Meeting Date: Tuesday 16 October 2012
Location: Committee Room 2, Level 5, Civic Centre, 1 Devlin Street, Ryde
Time: 4.00pm

NOTICE OF BUSINESS

| Item | | Page |
|-------------|--|-------------|
| 3 | 958 VICTORIA ROAD, WEST RYDE. LOT 8 DP 819902. Local Development Application for alterations and additions to existing dwelling. LDA2012/0047. <i>INSPECTION 4.20PM / INTERVIEW 5.10PM</i> | 11 |
| 4 | 62 DARVALL ROAD, EASTWOOD. LOT 11 DP 6247. Local Development Application for demolition of existing dwelling and erection of a attached dual occupancy. LDA2011/380. <i>INSPECTION 4.35PM / INTERVIEW 5.15PM</i> | 45 |

Figure 1: Subject site with zone for development indicated by cross-hatching

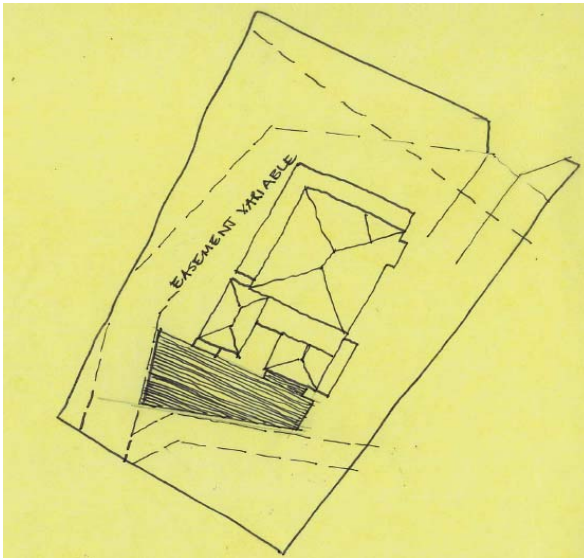
A desk top review of the survey plan was undertaken to determine the potential of an area on the subject site with the potential to support development. The review took into account the easements on the subject site and the required retention of the single storey rear wings. The below image identifies a ‘zone’ for potential development at the rear of the subject site identified by cross-hatching. The identified zone is to the rear of the existing rear wings and within an area defined by easements. It is recommended that the location of the easements is researched (in particular the “easement of variable width”) and more accurately plotted in consultation with the relevant authorities.

A new rear addition may be constructed in the identified zone for development and attached to the existing building, but must include the following features:

- Material quality (wall and roofing materials) to be sympathetic to the existing heritage item
- Fenestration and external architectural detailing including the fire stairs to be designed to be sympathetic with the existing heritage item.

- Demolition of the existing unsympathetic rear stair will be favorably considered. To facilitate access to the second level of the dwelling, the wall closing off the existing internal stair at the ground floor could be opened up.

Figure 2: Indicative potential form and roofline of a rear addition, constructed within the identified zone for development

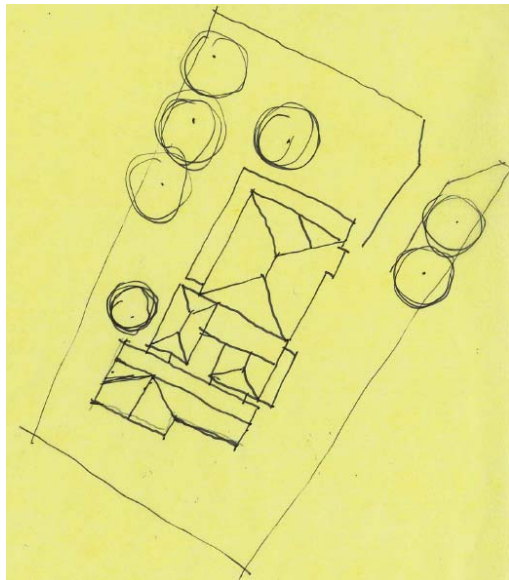
It is noted that Figure 2 is only indicative of any development, and any design should be carried out and works supervised by a suitably qualified heritage architect.

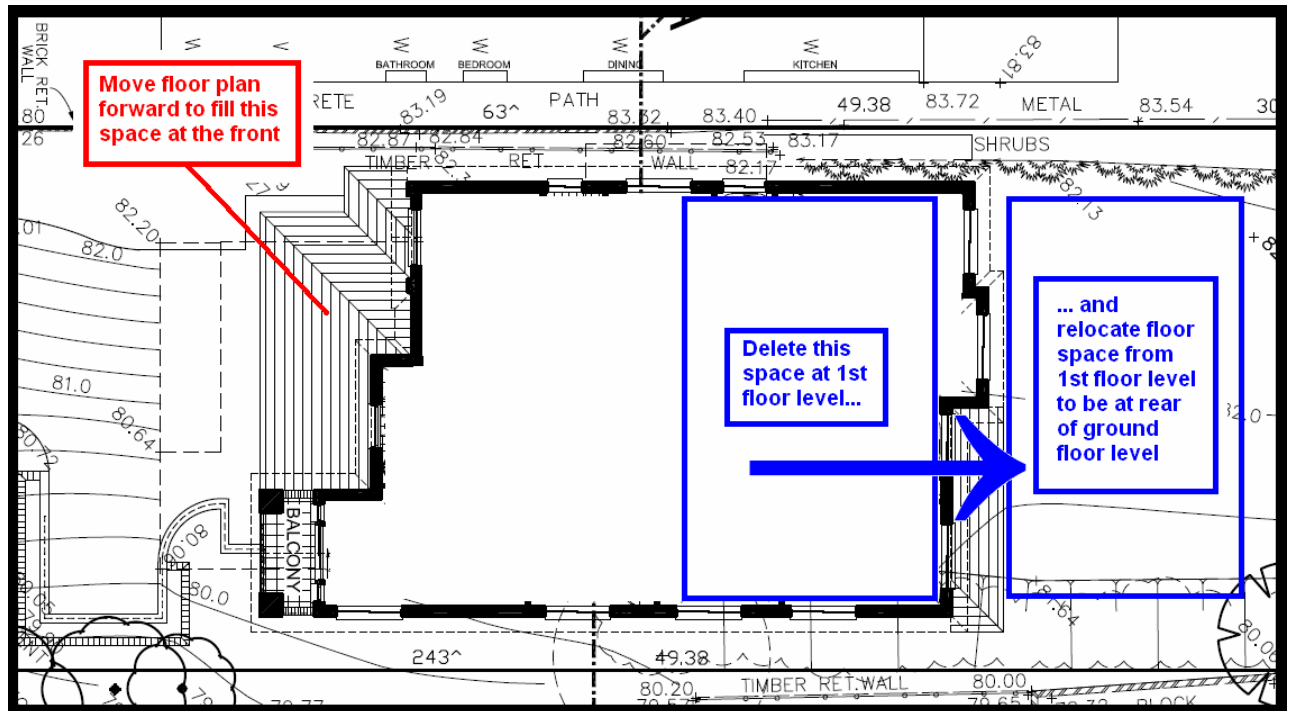
for this development are summarised below and shown in the marked-up plan below:

- Re-design the 1st floor level to move the floor plan forward to “fill” the space at the front of the dwelling; and/or
- Remove the rear portion of the 1st floor and/or extend the ground floor level towards the rear.

These design solutions have been suggested to the applicant on several occasions in meetings with Council officers during the processing of the application, but they have declined to make the requested amendments. The applicant has indicated that this is a “standard” design obtained from the housing company and any variations would incur a financial cost, and instead of amending the design to accommodate view sharing, the applicant has chosen only to justify the current design via a written submission.

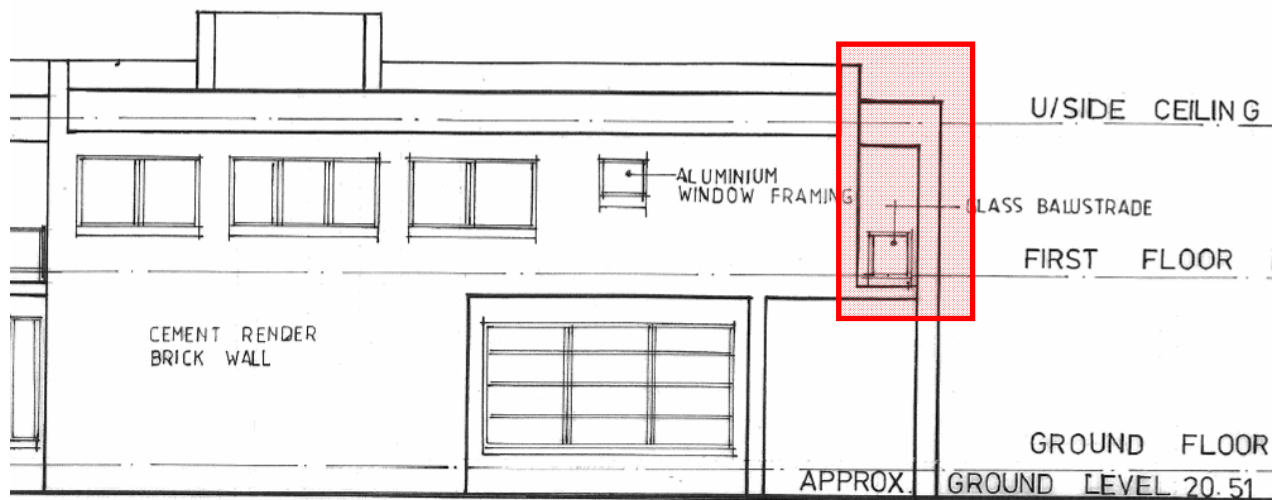
14 May 2012 – Council's Assessment Officer wrote to the applicant to request a detailed surveyed site plan and elevations (including a view impact statement) that clearly shows what impact the proposed development would have upon the views from the objector's first floor.

23 May 2012 – The applicant responded to Council via the submission of view loss diagram (including cover letter) showing the extent of views that would be maintained following development of the subject site and amended plans in which the rear setback of the dwelling house had been increased by 500mm (achieved by reducing the front setback and the length of the dwelling house). The applicant declined to relocate the dwelling house any further to the east on the basis that the proposed front setback was now at the minimum of 6 metres as required by the Ryde DCP 2010. The applicant also noted that an existing Camphor Laurel tree located at the north-west corner of the subject site is proposed to be removed, which would open up views from the objector's property.

25 May 2012 – Council's Assessment Officer advised the objector and included the amended plans and cover letter received from the applicant on 23 May 2012, explaining that the objector had relocated the dwelling house to the east by 500mm.

North elevation showing the *original* design of the rear balcony with protruding built form over.

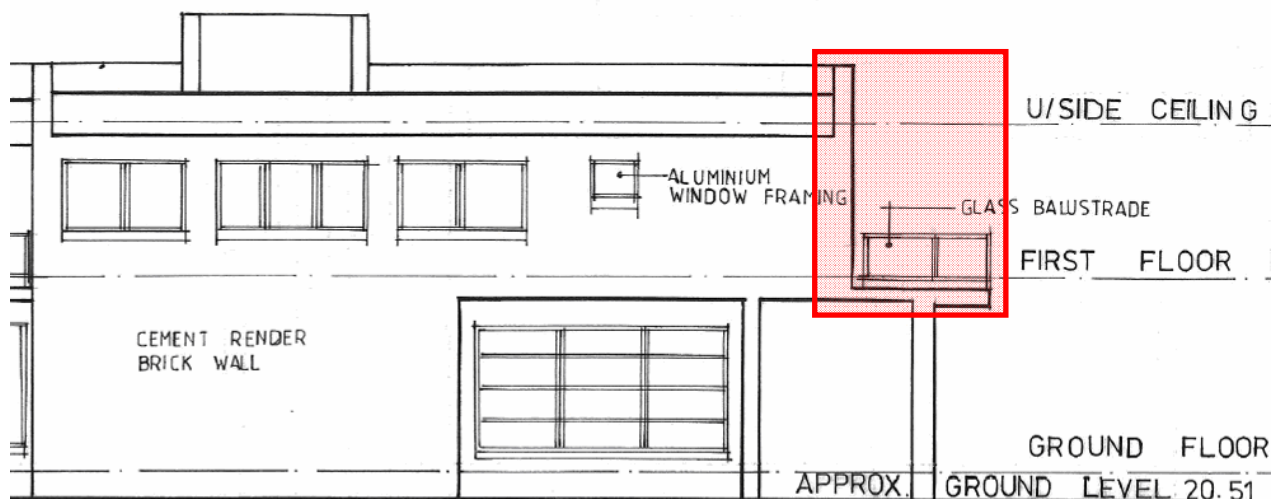
8 June 2012 – The objector wrote a second submission to Council, identifying that the extent of the protruding built form over the rear balcony had not been taken into consideration in the applicant's view loss diagram, and claiming that the removal of the Camphor Laurel tree would result in only a marginal improvement in views, if at all, and any additional views obtained would be to the properties located at 61B Wharf Road, Gladesville and 2 Pile Street, Gladesville. Furthermore, the objector stated that the removal of the tree would result in a loss of privacy as it presently forms a visual barrier between the objector's property and the aforementioned properties.

29 June 2012 – Further amended plans were submitted by the applicant to Council, in which the protruding built form over the rear balcony was deleted.

North elevation showing the *revised* design of the rear balcony with protruding built form deleted.

Proposed east / west section through the dwelling house showing the elevated front steps and internal entry foyer.

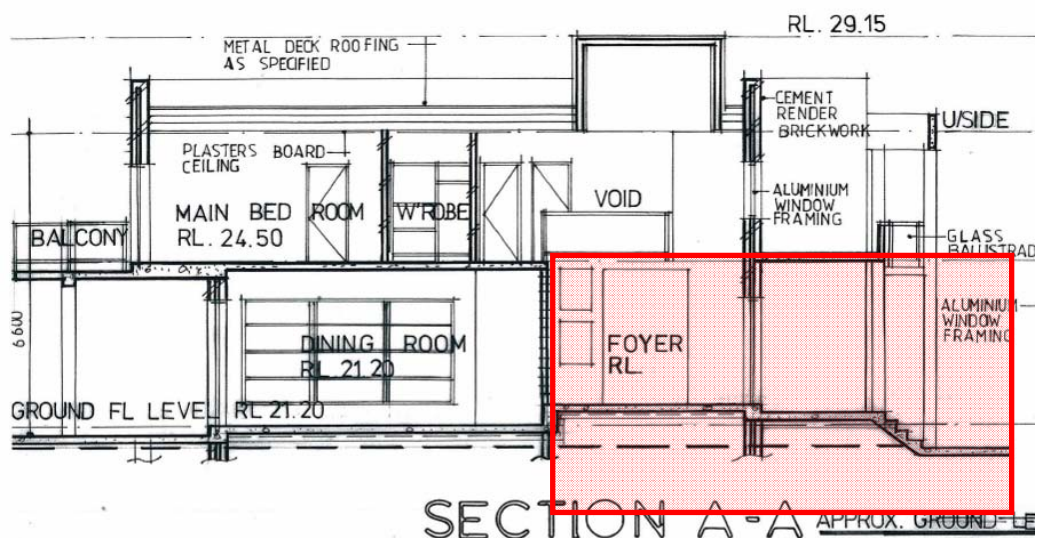
- (i) *Maximum fill within the building footprint* – the proposed development will require 940mm of fill above ground level within the building footprint below the front door, which exceeds the maximum extent of fill by 40mm. This is considered to be a negligible non-compliance and it is important to note that the non-compliance is limited to the front entry portico and internal entry foyer only. From the foyer, steps will lead down into the living and dining rooms on the northern side of the dwelling house on the ground floor level.

Proposed section through the backyard including retaining wall, rear deck and swimming pool area.

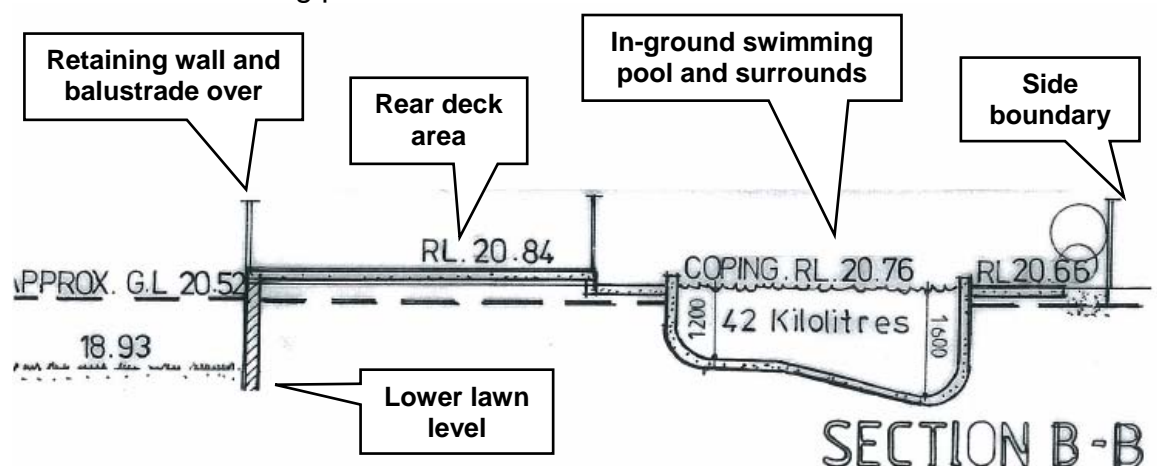
- (ii) *Maximum fill outside the building footprint and maximum height of retaining wall* – the applicant proposes to relocate the existing retaining wall that runs the length of the site by approximately 1 metre to the south, and to fill behind it. This will result in new fill of up to 1410mm at the rear lawn for a narrow strip of approximately 1 metre width behind the new retaining wall.

The southern lawn level is proposed to be cut by approximately 300mm to provide for a level area, which will result in the retaining wall having a height of up to 1.91 metres behind the dwelling house. In addition, the applicant proposes to increase the level of the existing rear lawn area, with the new lawn level being 300mm higher than the existing lawn and the new concrete area immediately outside the dining room being up to 750mm above the existing lawn level. The DCP permits up to 500mm of fill provided that the filled areas “do not have an adverse impact on the privacy of neighbours”.

In this instance, it is considered that the proposed increases to existing ground levels in the rear yard will further exacerbate an existing undesirable situation whereby the existing levels within the backyard allow overlooking into the rear private open space of the adjoining property to the rear (No. 2 Pile Street). Refer to photos below. Therefore, it is recommended that a condition of consent be imposed restricting the rear private open space areas and the proposed new retaining wall to no higher than RL 20.45. This will still provide for a flat lawn area at the rear whilst minimising further privacy impacts to the rear.
